Waimea Community Dam: Peer review of Waimea Plains hydrology underpinning the proposal

Tasman District Council

September 2016

LC2659

Figure 1: Total groundwater flow in the period of November and April in the Waimea Plains (reproduced from Fig. 11 of GNS, 2003)

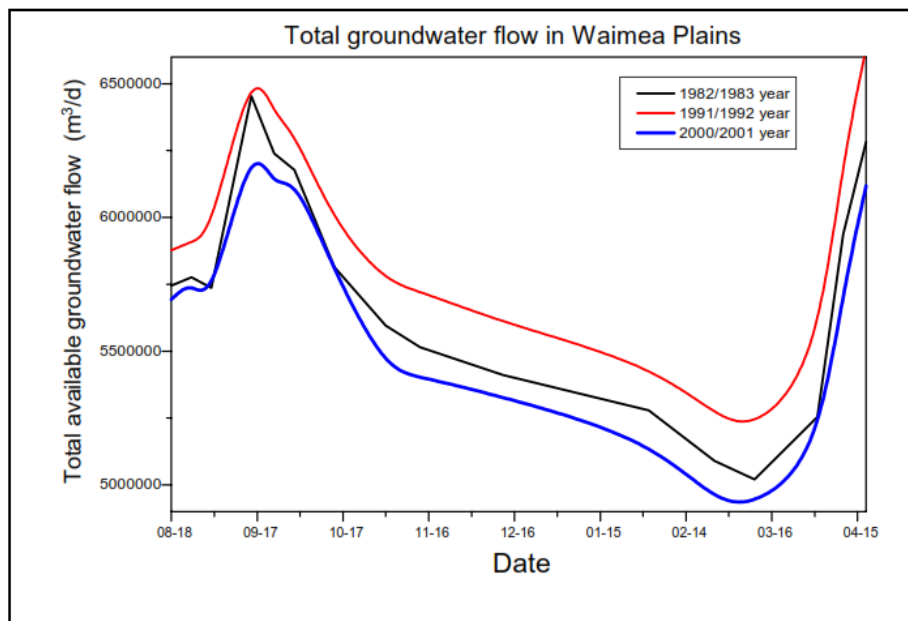
The errors noted relate to the units used in Figure 11 of GNS (2003) (reproduced below in Figure 1) and Table 8, where the groundwater through-flow is over-reported by a factor of 7 because weekly (m³/week) rather than daily (m³/day) data have been plotted, and these data are also described too loosely as ‘available groundwater flow’ when this water is not all ‘available’ for extraction. These are reporting errors rather than a modelling error and have not affected any of the conclusions reached by GNS in that report.

A: We have contacted GNS Science about correcting the reporting errors in their 2003 report. These changes can apparently be made and the revised report made available online. The errors are drafting errors rather than modelling errors of consequence for decision-making.

Figure 4: Modelled and measured Wairoa River flows versus losses (to Wai-iti confluence): low flows

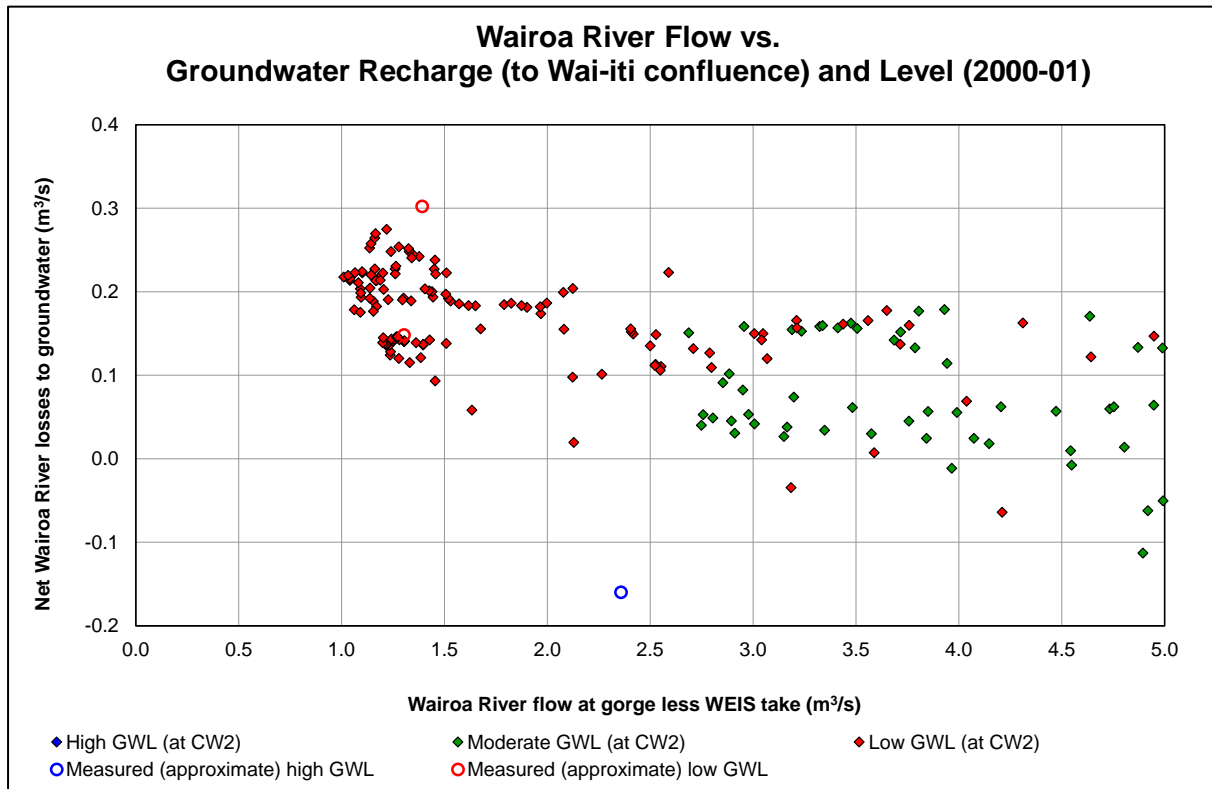
The model's ability to replicate measured flow losses is presented in Figure 4 for the 2000/01 model period. Here, both modelled and measured losses in the Wairoa River between the gorge and the Wai-iti confluence are plotted (allowing for WEIC takes). This is generally the losing reach of the river. To demonstrate the relationship with groundwater levels, losses are presented for periods of low, moderate and high groundwater levels based on Delta Zone well CW2 as an indicator.

Figure 4 presents this relationship for low gorge flows (up to 5 m³/s³). Though it appears there is an upper limit to the river losses, at higher flows the losses are a little greater (and more variable). This is demonstrated in Figure 5. Although there are only a few measurements with which to compare, the model is consistent with the few that are available.

A: River recharge to groundwater is dynamic, highly variable, and dependent on multiple factors, including river stage height and depth to underlying groundwater. Generally, as river flows increase, river recharge to groundwater increases. Similarly, as groundwater levels drop, river recharge to groundwater increases. Modelled response is consistent with measured.

Figure 8: Modelled TDC Nursery site river flows comparing daily stresses with hourly river flows and diurnal groundwater pumping

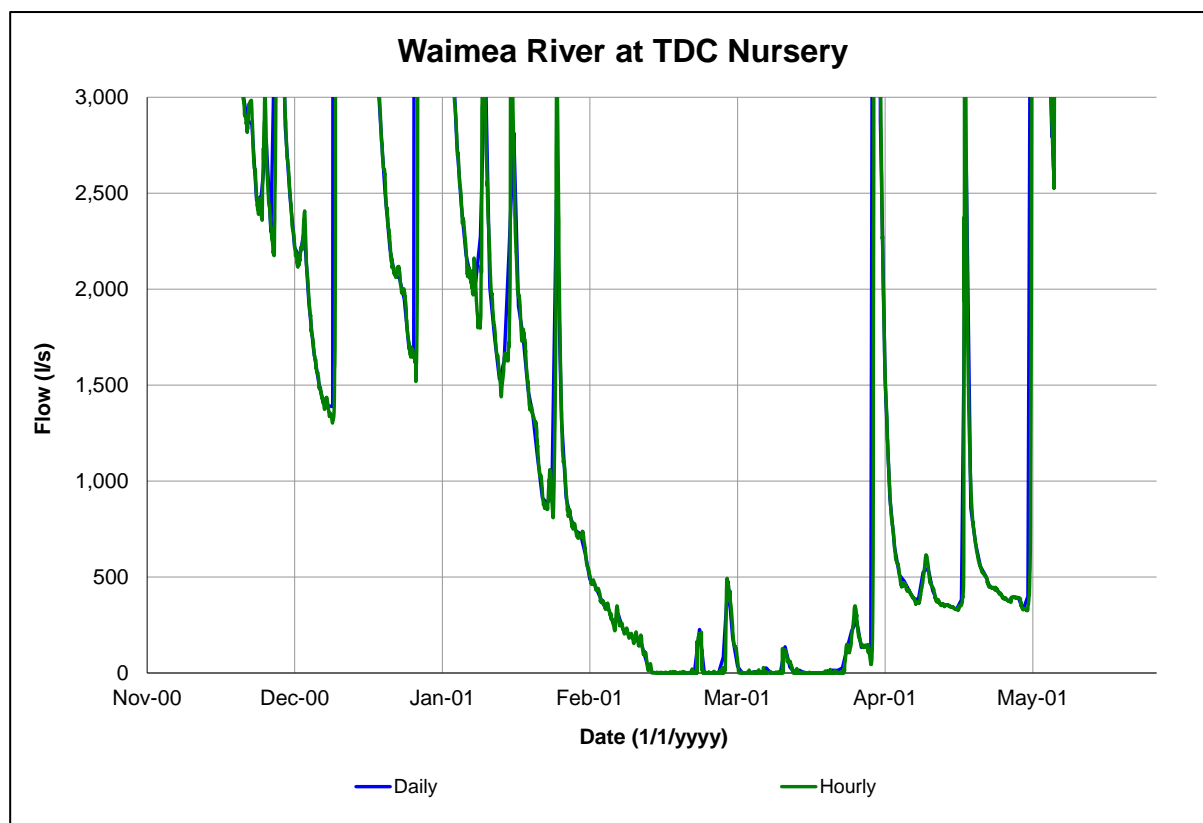
Q: Do diurnal variations in river flows and pumping affect model predictions?

Based on Figure 8, the predicted flows at TDC’s Nursery site are very similar whether daily or hourly river flows are used, particularly during the low-flow periods when important management decision are being made. A few points to note:

A: Modelling sub-daily river flows does not noticeably affect the groundwater model's predictions, particularly for the extended stable, dry periods where water management is critical. No pumping data are available to test the effects of sub-daily values of groundwater abstraction, but due to the storing and buffering nature of the groundwater system, there is also likely to be an insignificant difference compared to the assumption of daily-averaged abstraction.

Figure 9: Modelled Nursery river flows comparing daily and hourly river flow stresses with diurnal groundwater and WEIC pumping

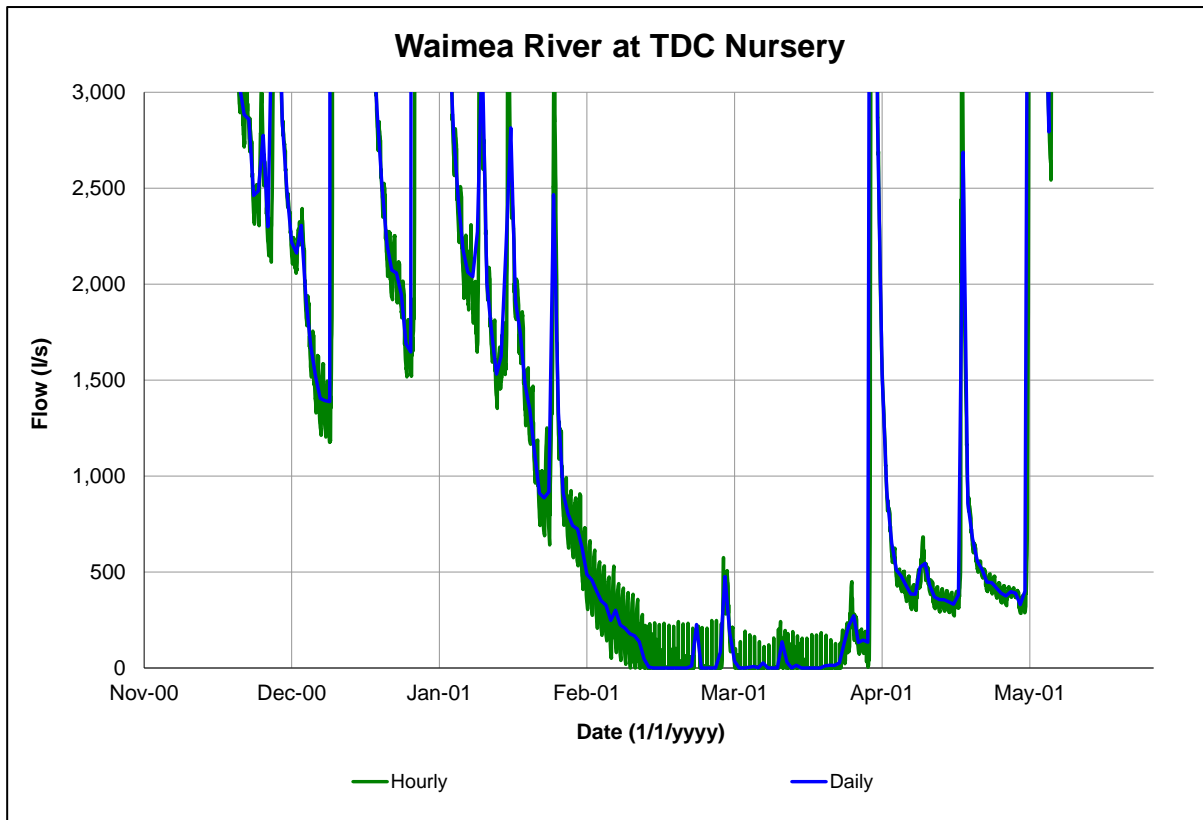
In Figure 9, the same diurnal pumping assumption has been applied to the WEIC river water take below Wairoa Gorge. The time-varying river flows propagate downstream to the Nursery site in the Waimea River. However, this level of river flow fluctuation is not seen in the recorded flows available at the TDC Nursery recorder site and therefore appears unrealistic.

Figure 12: Modelled flows at Nursery for calibrated state and with dam flow releases

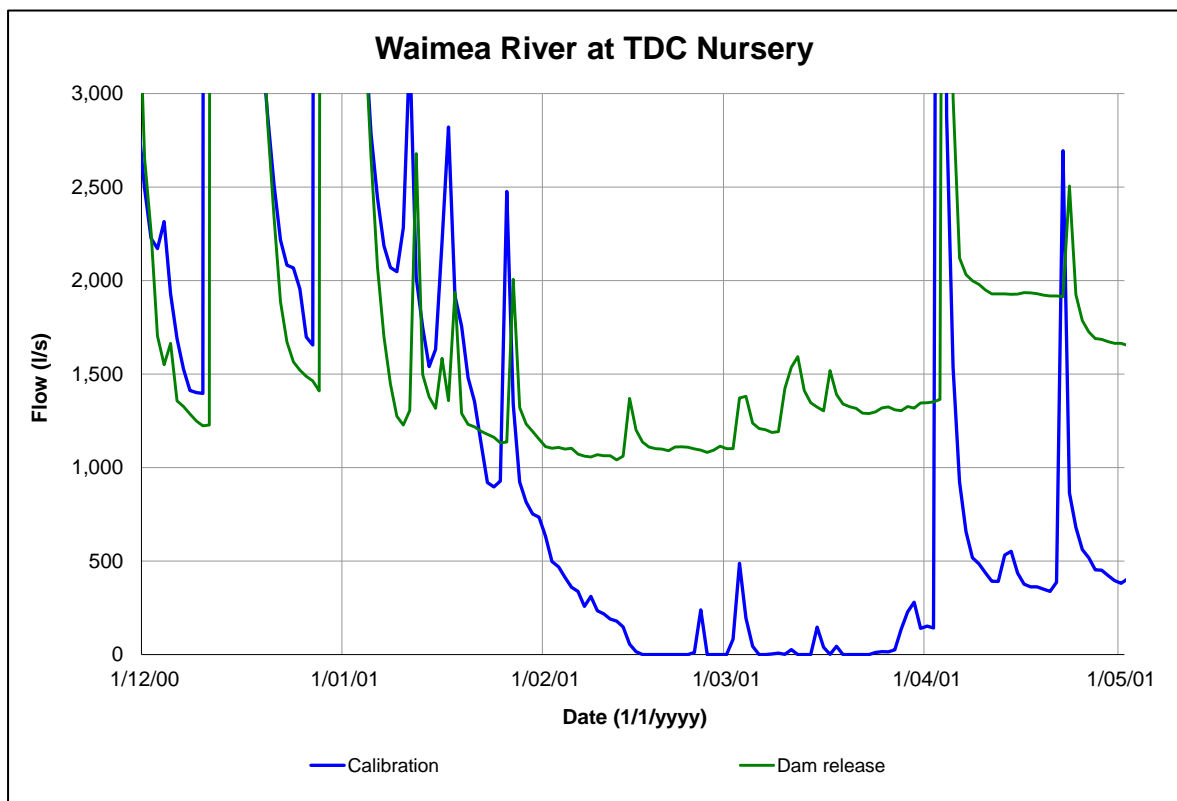
Comparing Table 3 and 4 with Figure 12 shows that while additional groundwater recharge is generated from the augmented river flows, a reasonable proportion of the additional flow remains in the river system and travels down to directly augment surface flows in the lower reaches. This additional surface flow mitigates the additional stream depletion effects from the extra groundwater pumping, and supplies a larger minimum river flow (improving aquatic habitat). Higher river flows also reduce the risk of seawater migrating upstream.

As can be seen in Figure 12, modelled flows over the dry summer period with the Dam Release are substantially higher than without. River flows under the Dam Release scenario are lower over December and January because natural flows at the Wairoa gorge are (by and large) greater than 3,077 l/sec and dam releases have been switched off. Lower flows then result from the additional stream depletion effects of the additional groundwater pumping simulated in the catchment, without mitigation from released water.

Figure 13: Modelled Wairoa River losses comparing Calibration and Dam Release scenarios

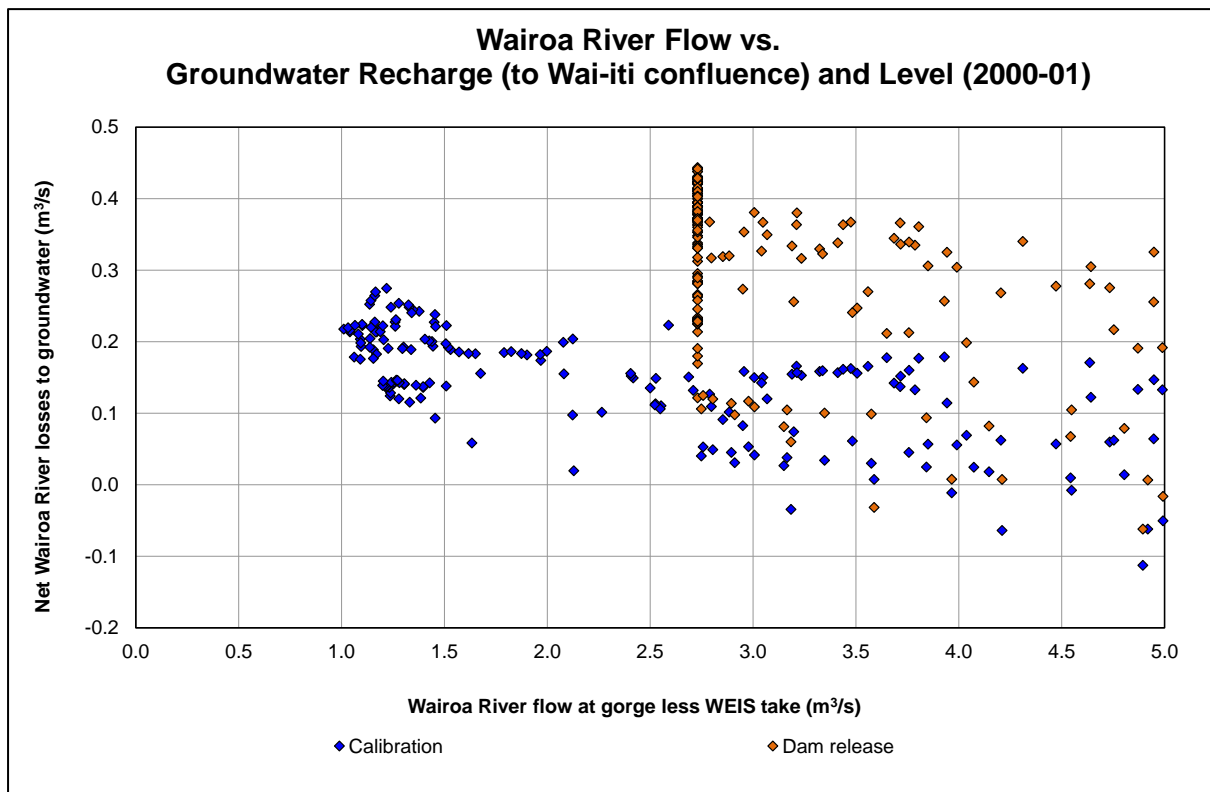
If the proposed Lee Valley dam releases additional water to maintain a minimum flow of 1,100 l/sec, the river flows will be higher and so too will groundwater recharge. This is demonstrated in Figure 13, which compares modelled Wairoa River losses under the Calibration scenario (which is the same modelled data presented in Figure 4) with losses under the Dam Release scenario. River losses are larger while the dam releases water during low flow periods because river flows are higher. The target minimum flow of 1,100 l/sec is achieved with a minimum gorge flow of 3,077 l/sec at the Irvines recorder site, which reduces to approximately 2,730 l/sec after the WEIS take is removed; this is clearly visible on the plot with a range of river losses to groundwater of 40–430 l/sec occurring as a consequence of flow releases from dam releases. Additional groundwater pumping in the Dam Release scenario also means that losses at other non-low-flow periods are also different.

A: The amount of water that can be infiltrated into the groundwater system is limited by the driving head between the river and groundwater and the ability of the groundwater system to receive the water. Larger river flows (as would be expected with augmented river flows) will result in increased river recharge.

Figure 15: Net river recharge for various scenarios with and without weirs

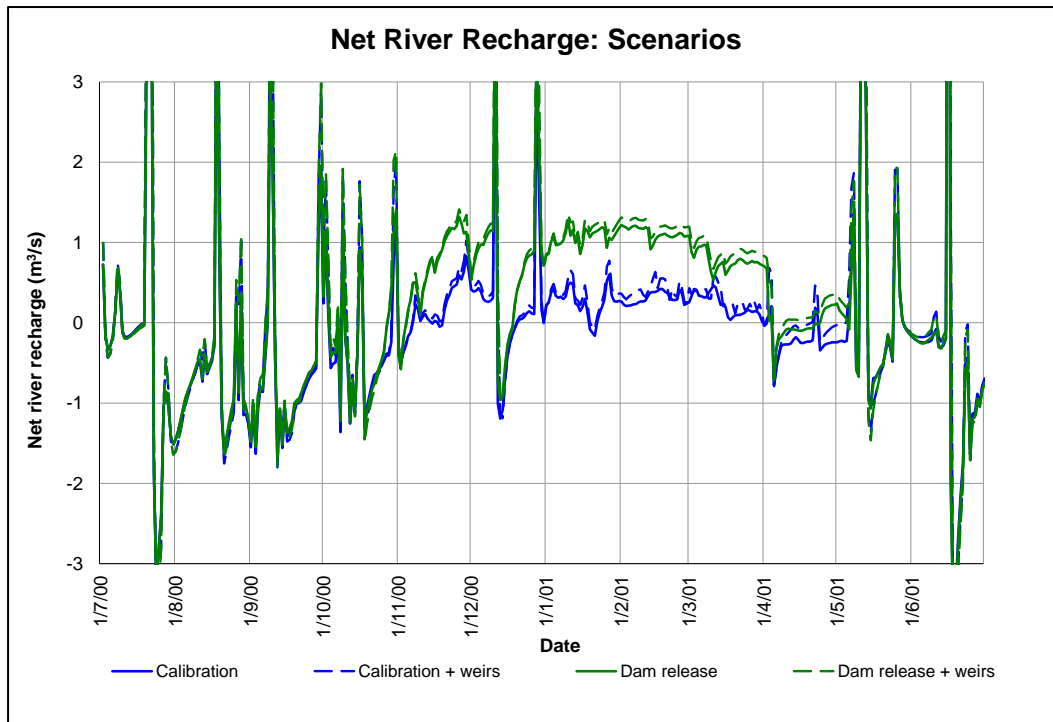
This model was then run with and without dam releases. Figure 15 presents the net river recharge (for the full model domain) for both the calibrated model and the dam release model, comparing without weirs (the solid line) and with weirs (the dashed line). A very small increase is predicted due to the weirs, considerably less than the difference in recharge comparing Calibration and Dam release scenarios.

A: While weirs do increase the river recharge to groundwater other than in periods when the river is dry, their positive effect is likely to be limited to the vicinity of the weirs, and considerably less than the positive effects of augmented river flows. In addition, without augmented river flows during low flows, upstream weirs may deprive flow from downstream reaches, drying the lower river sooner.

Figure 19: Measured Wai-iti dam releases and downstream responses

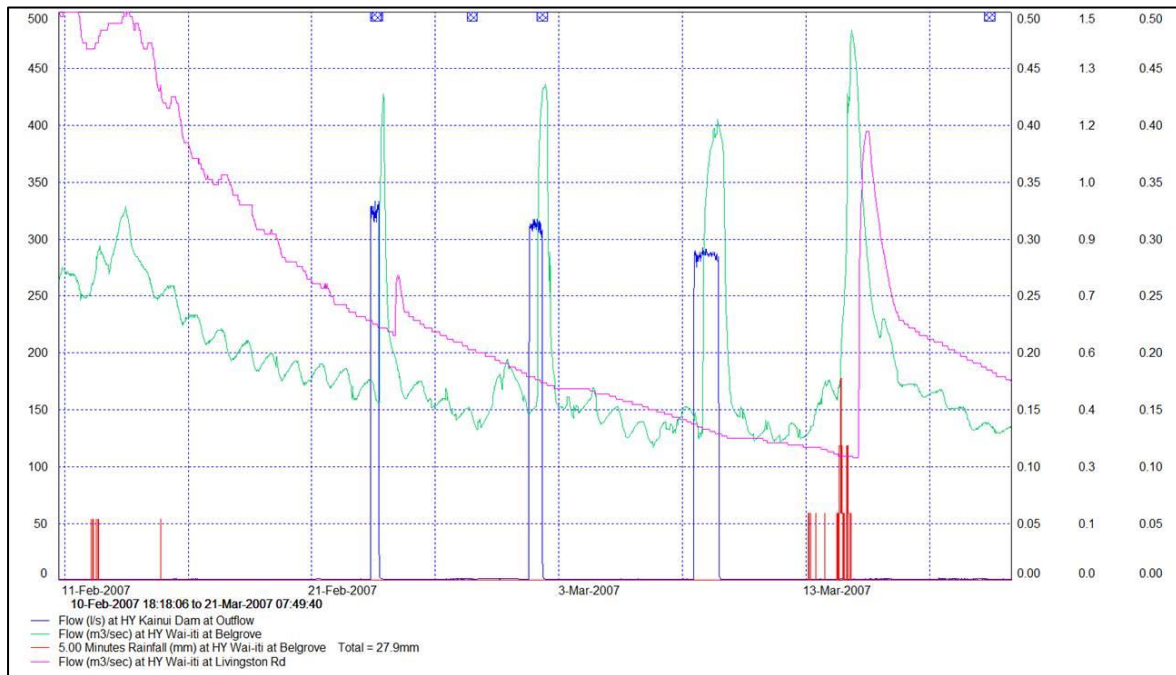
Q: Does TDC experience with Wai-iti's Kainui Dam give confidence the Lee Dam will work as intended?

From Figure 19, a clear and immediate response is observed at the down-gradient Belgrove river site as the release is switched on and off. TDC staff try to maintain a flow of 100 l/sec at Livingston Road by releasing water from the dam during dry periods. When they achieve this, the river usually dries just below the bottom weir during dry periods. Prior to the dam, the river would normally go dry much further upstream of the weirs.

A: The Wai-iti Dam is somewhat smaller than the proposed Lee Valley Dam, and designed for a more constrained purpose (riparian supply rather than catchment augmentation). However, it is clear from the little data available that releases from the dam do provide obvious and rapid responses in groundwater through increased river flows and recharge.
